Coca Cola Building
Master Development Plan
Architect's Project No. 0718
August 17, 2007

ADDENDUM NUMBER TWO

ADD2-1A DATED AUGUST 16, 2007

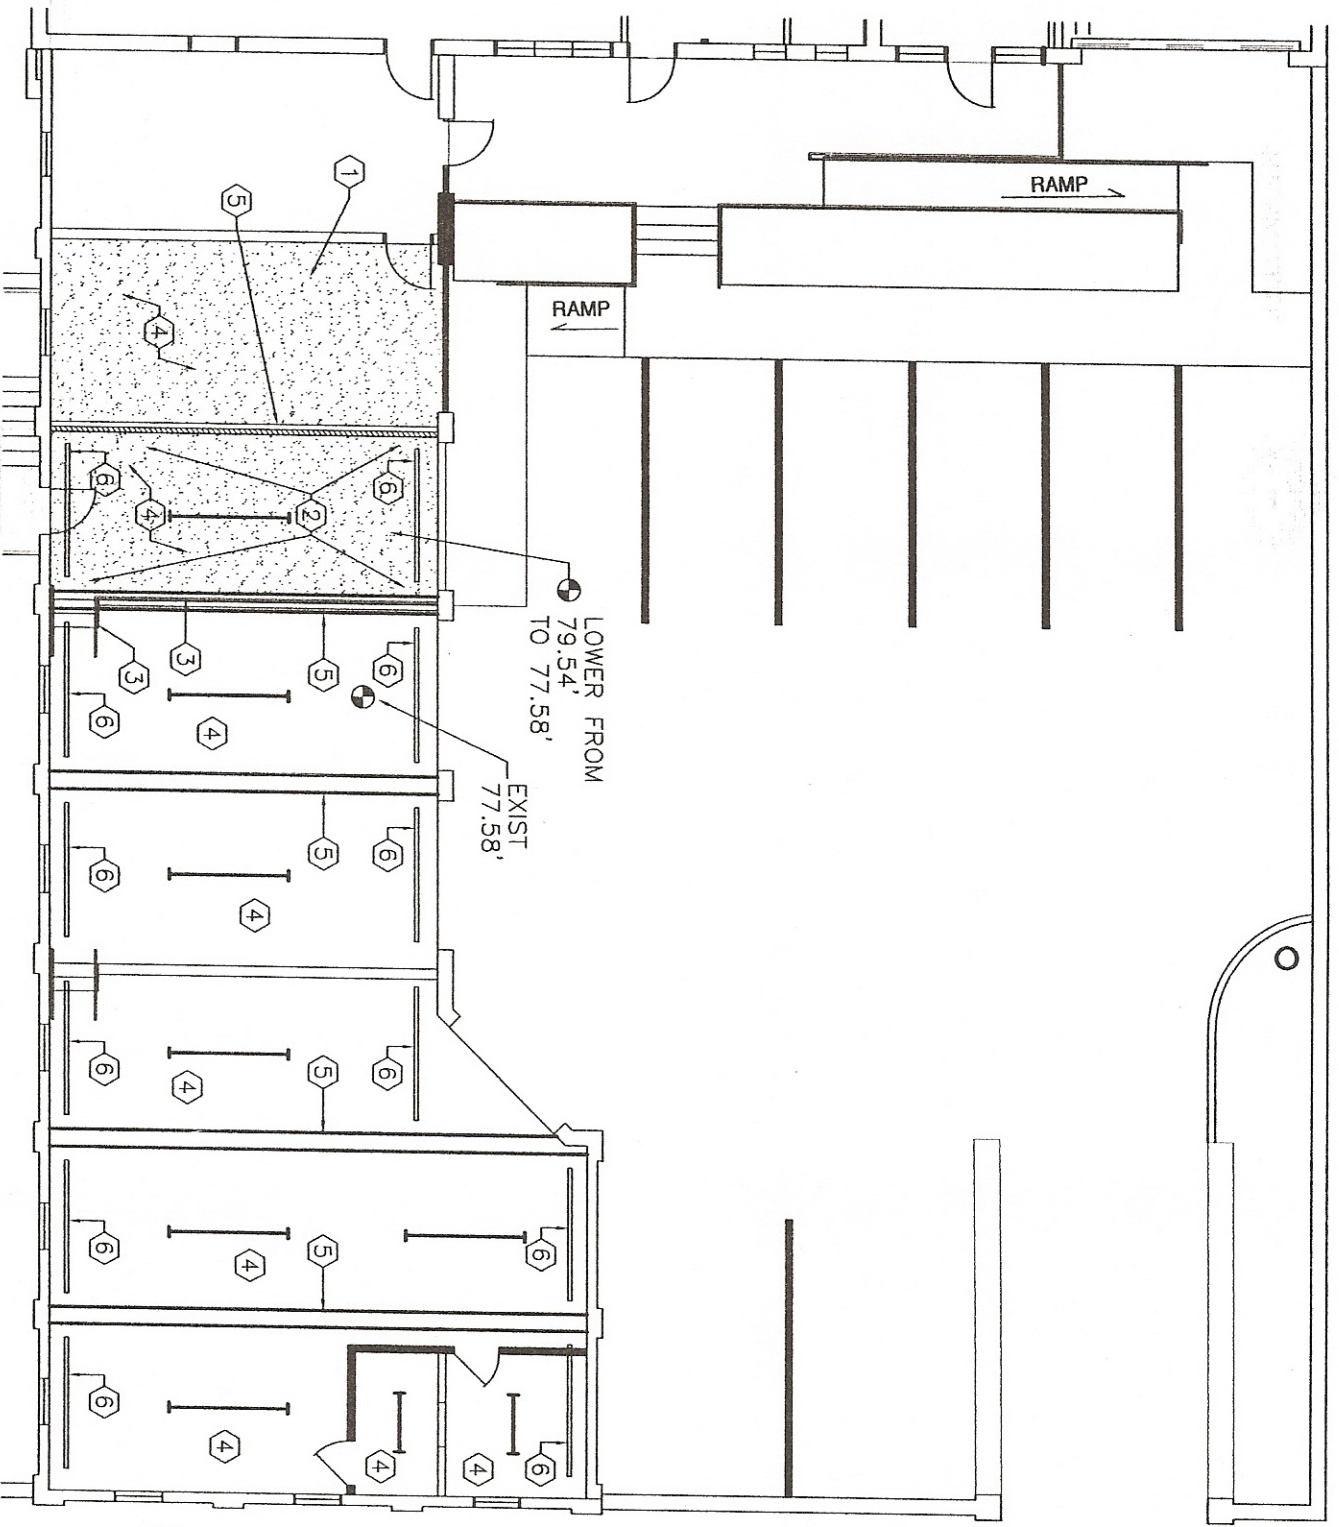
- A. See Keynote 2: For removing and lowering one existing garage bay slab on attached sheet Add2-1A**

- A. See Keynotes 1 and 2 for removal of one Bay of the existing garage slab on attached sheet Add2-1A.**

- ① POUR NEW SLAB ON TOP OF EXISTING PER KEYNOTE 21 OFF SHEET A1-1.
- ② REMOVE EXISTING CONCRETE SLAB IN THIS BAY IN ITS ENTIRETY. LOWER GRADE AS REQUIRED. TO INSTALL NEW 4" CONCRETE SLAB WITH WWF AT AN ELEVATION OF 77.58 TO MATCH EXISTING BAY SLAB ELEVATION TO THE SOUTH.
- ③ OMIT RAILING AND STEPS BETWEEN BAYS.
- ④ INSTALL TWO LAYERS OF 5/8" TYPE "X" GYPSUM BOARD TO THE BOTTOM OF EXISTING WOOD ROOF JOISTS. (PAINT)
- ⑤ FUR AROUND EXISTING STEEL BEAMS WITH TWO LAYERS OF 5/8" TYPE "X" GYP. BOARD ON 1 5/8" METAL STUDS @ 16" O.C.
- ⑥ CONTINUOUS ALUMINUM SOFFIT VENTS IN EACH BAY.
